MXD INFILL DEVELOPMENT CONCEPT PLAN

RESPONSE TO COMMENTS

CAMBRIDGE, MASSACHUSETTS
ISSUED NOVEMBER, 2016

IDCP RESPONSE TO COMMENTS

FIGURE R1.5.1

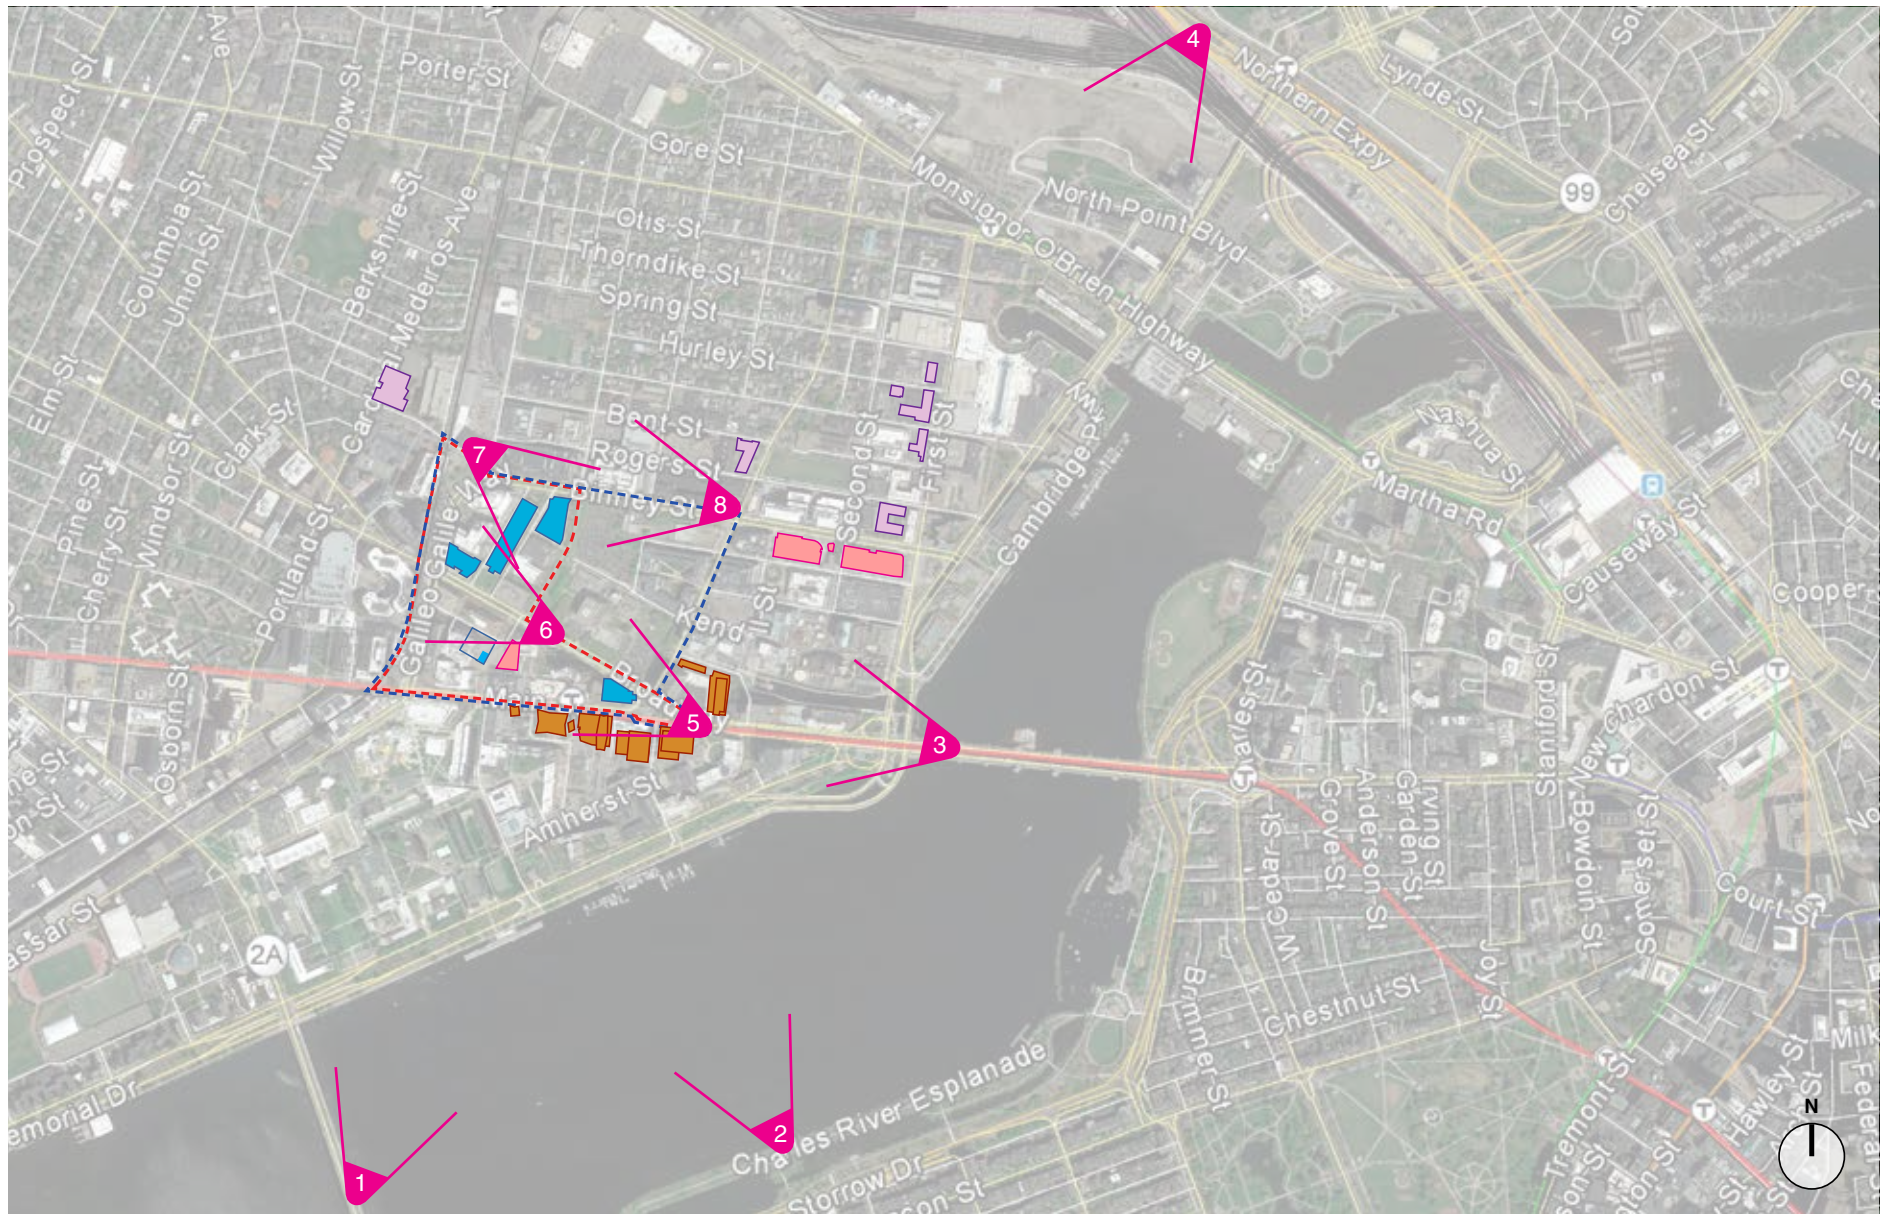
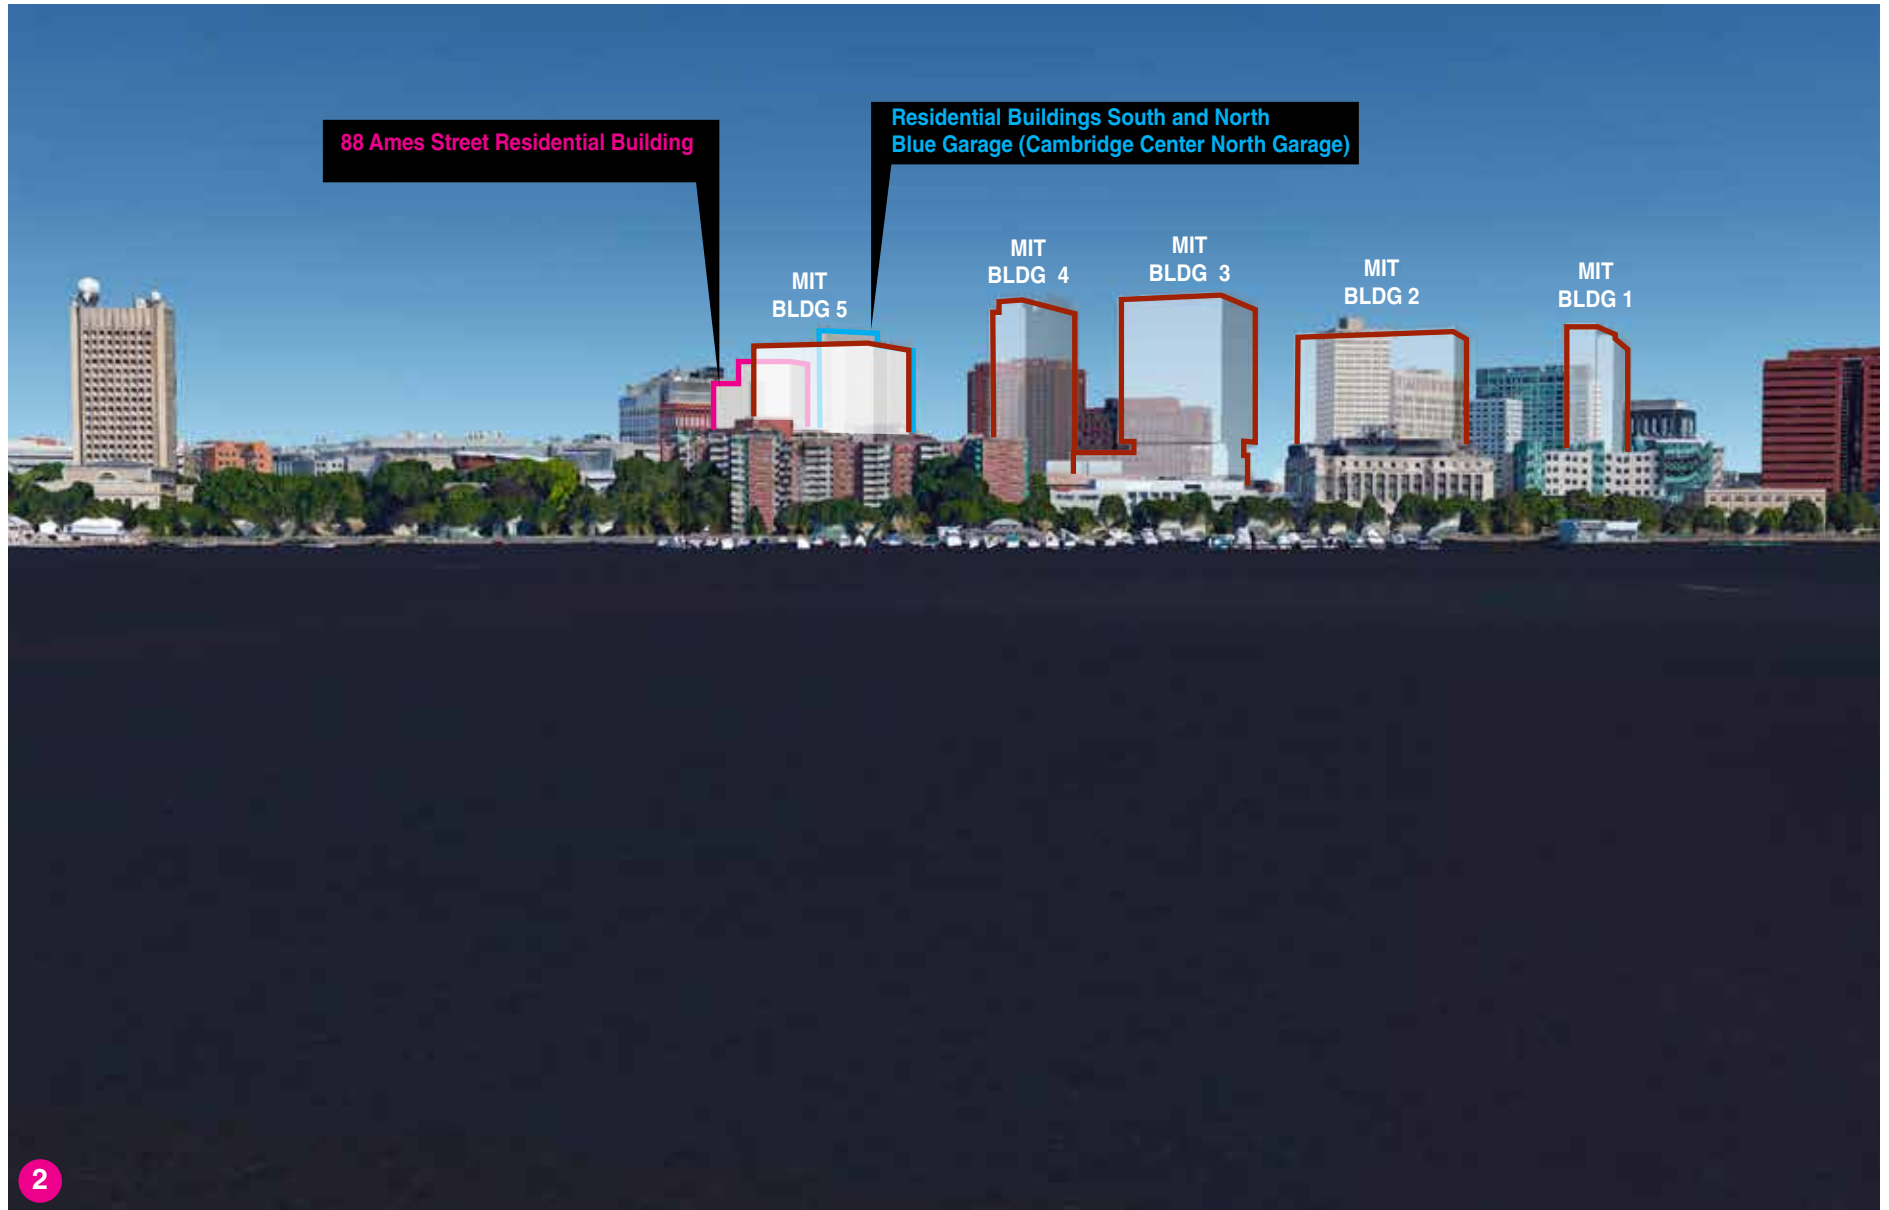
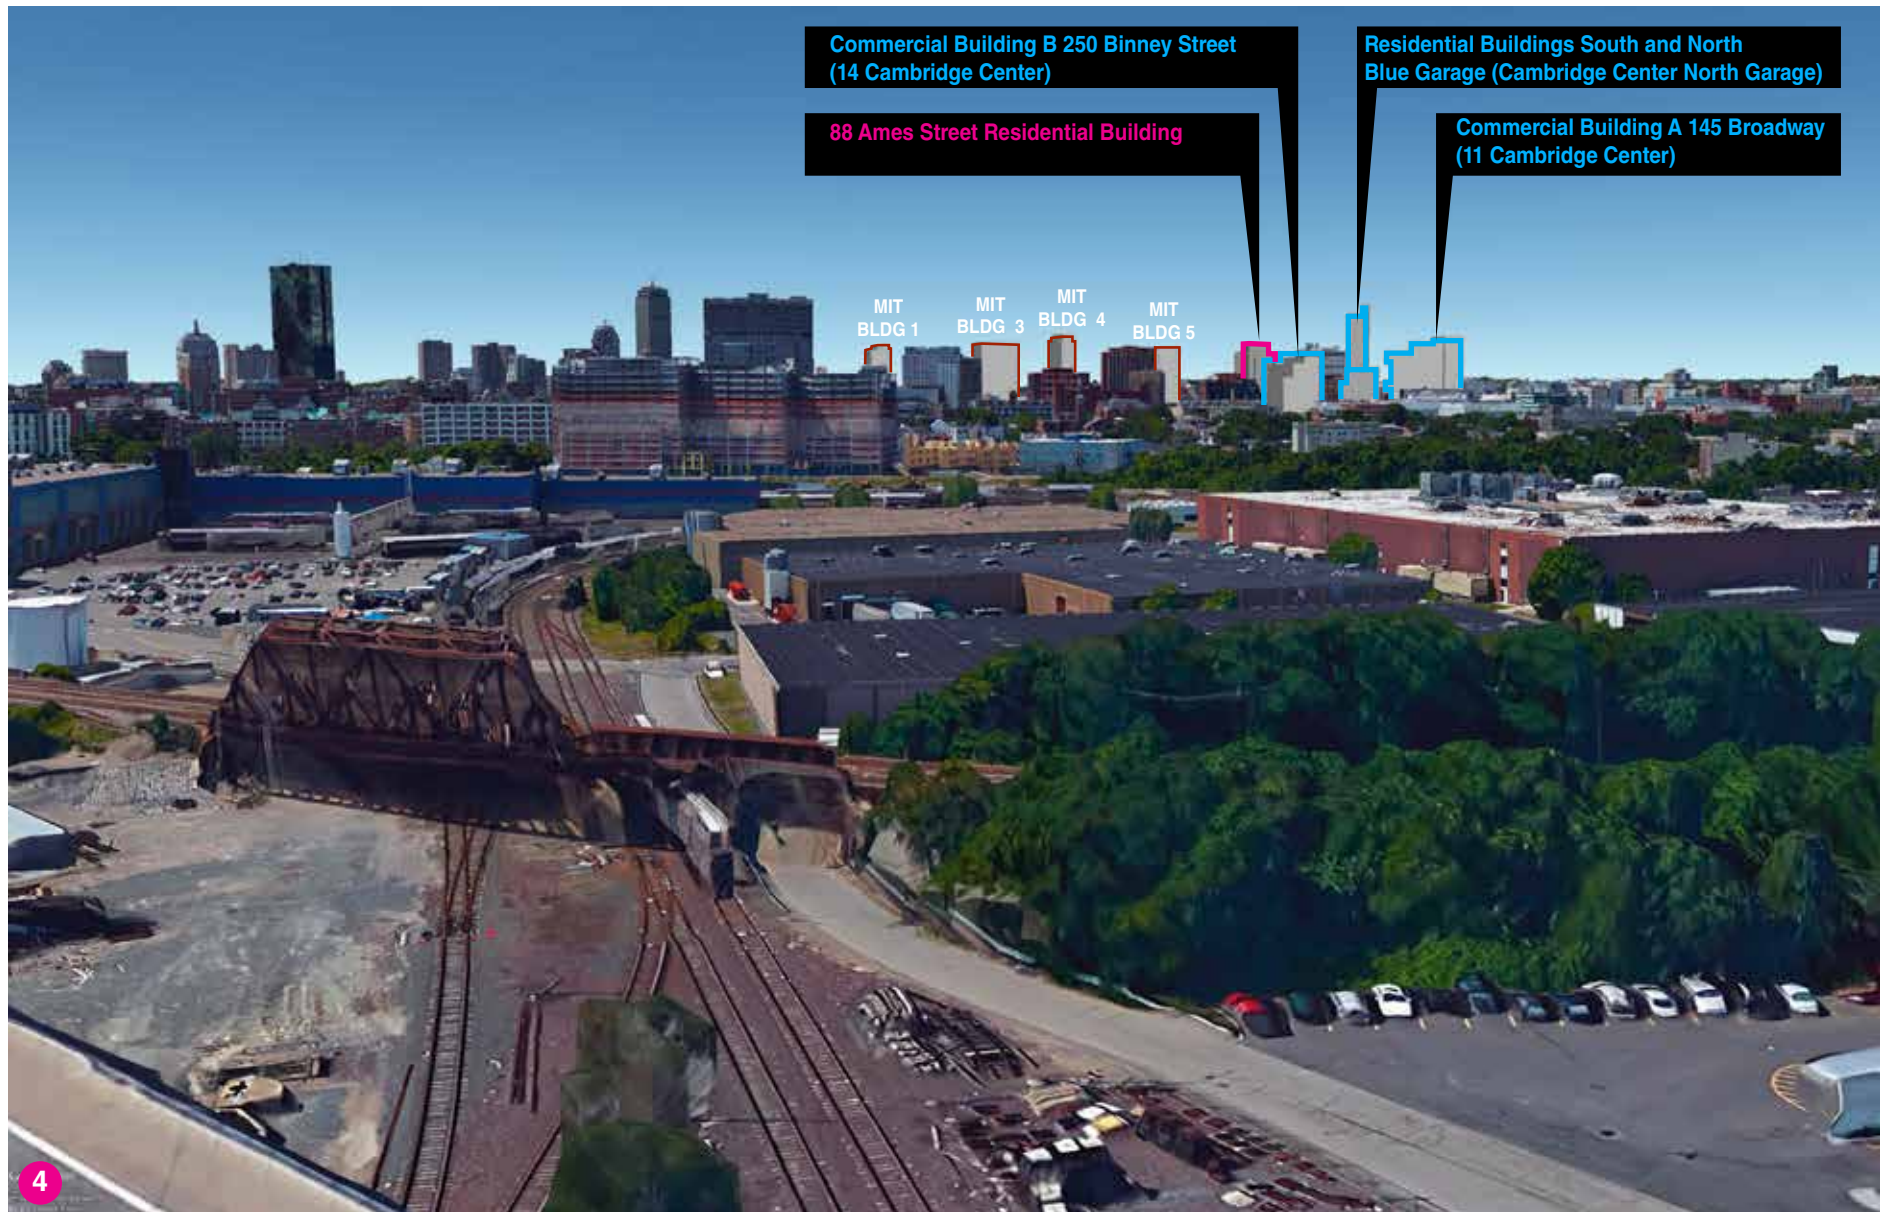
R1.5.1 DISTANCE VIEWS OF THE PROJECT: The CRA Board has requested additional massing views of the project from various distances, especially the South Residential tower. **FIG. R1.5.1A-F** represents views from similar locations to the requested views from 88 Ames Street Residences Project. Massing views include the proposed MIT PUD Projects to represent the future context of the MXD proposed buildings.

FIGURE R3.1.1

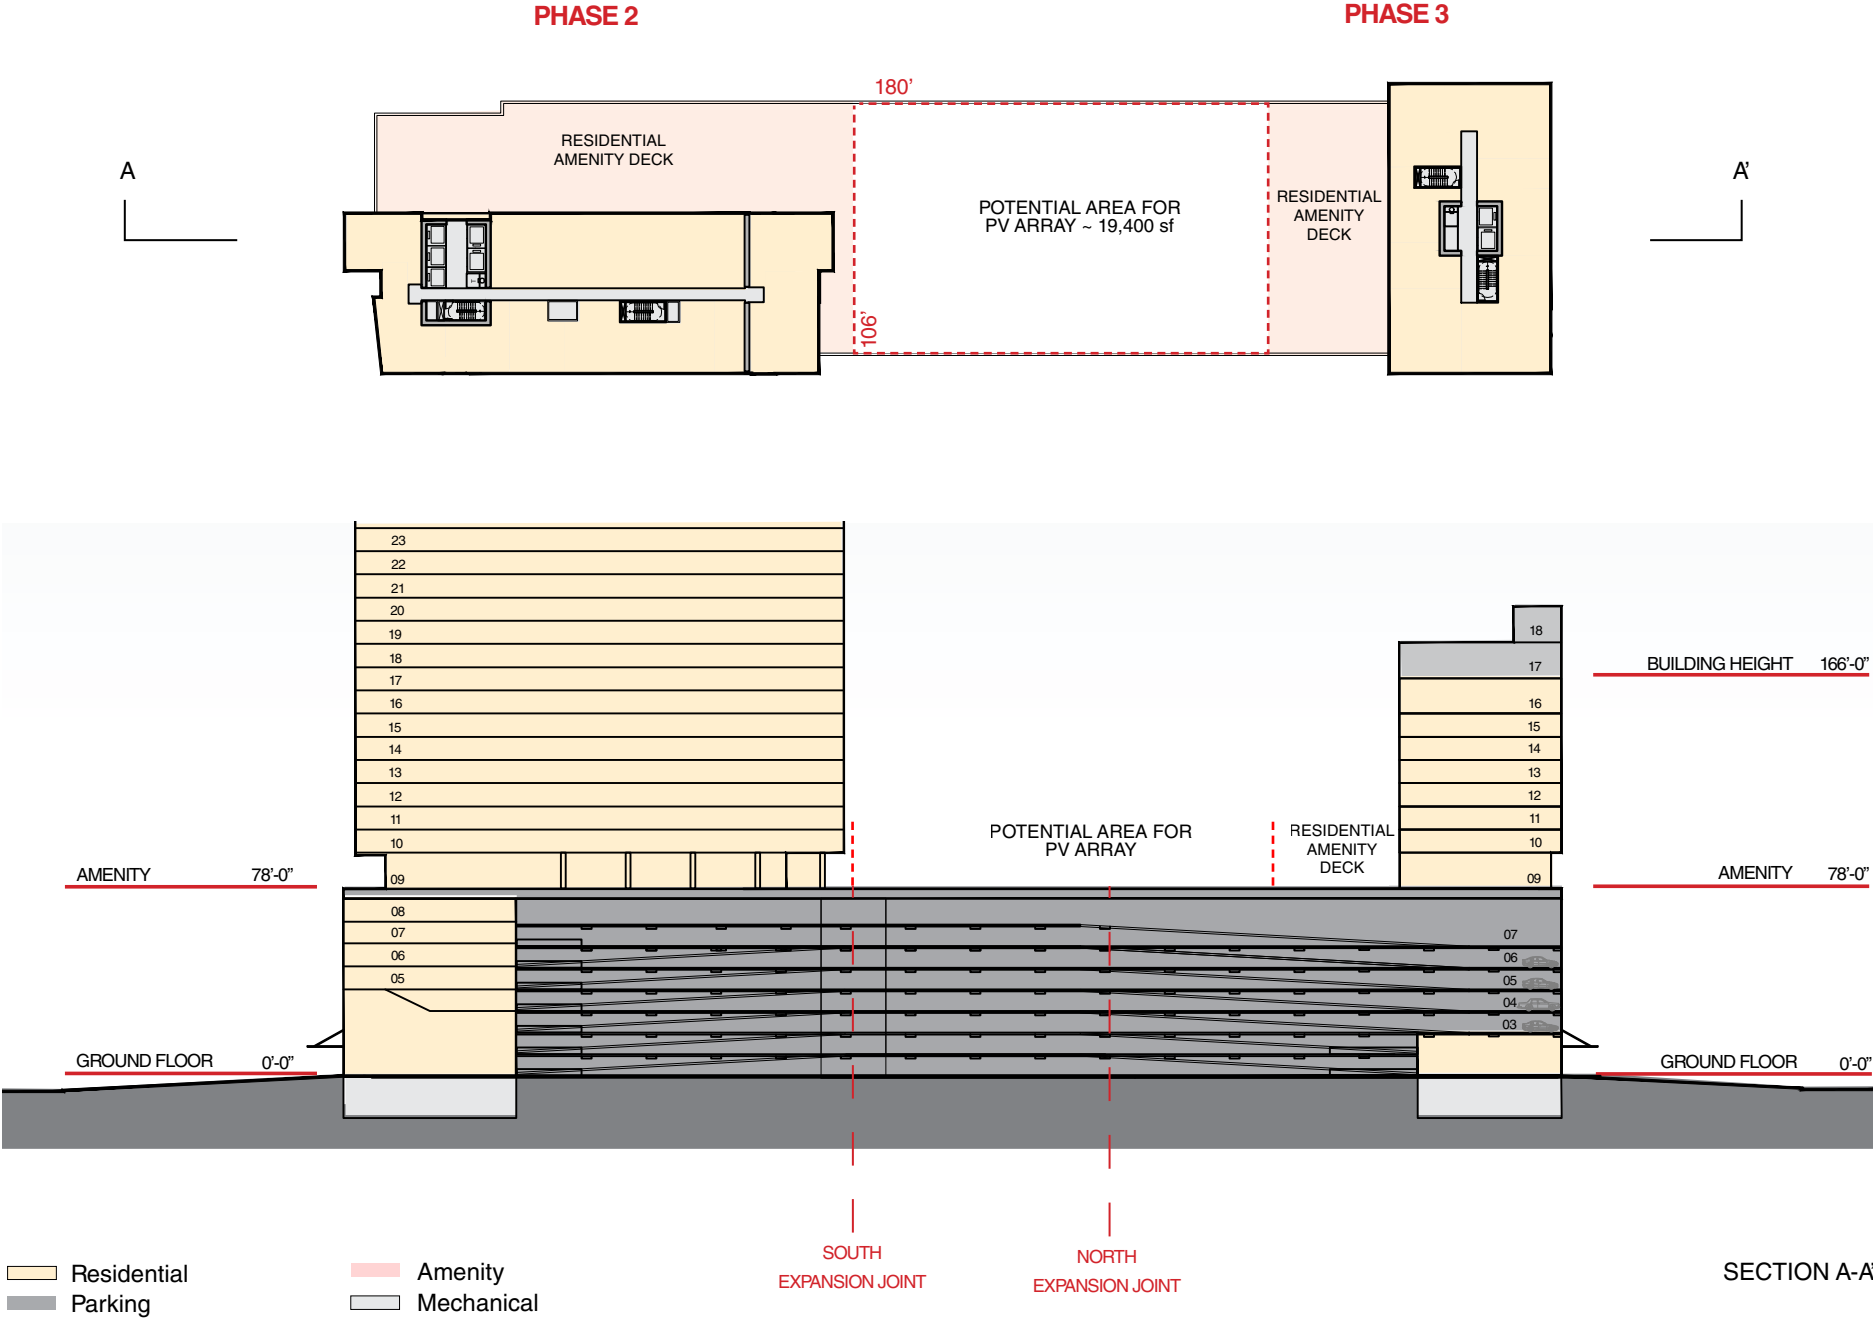
Applicant received several comments and questions about whether the Blue Garage will include open space for residents and what other uses may be considered in areas that are not private. As shown in **FIG. R3.1.1**, the Blue Garage will include two, separate private open spaces immediately abutting each residential project on the north and south sides of the garage. The area in between both open spaces is proposed as a solar array that will provide energy generation specifically for the residential projects.

Applicant was requested to provide an approach on balancing solar and green roofs. Green roof and solar generation cannot exist in the same, exact space and serve their intended purpose. The exact balance and presence of either or both green roofs and solar generation facilities will depend upon the solar conditions that apply to each building. **FIG. R3.1.1** shows the balance between solar and occupied, green roof top space that applies to the Residential Buildings on the North Garage. In general, green roof treatments will be concentrated on roof top areas that are in shade but still allow for plant growth but are less productive potential locations for solar generation. Additionally, solar facilities may be vertically installed on rooftops with proper solar orientation. Details for Commercial Building A and B will be provided during Design Review.
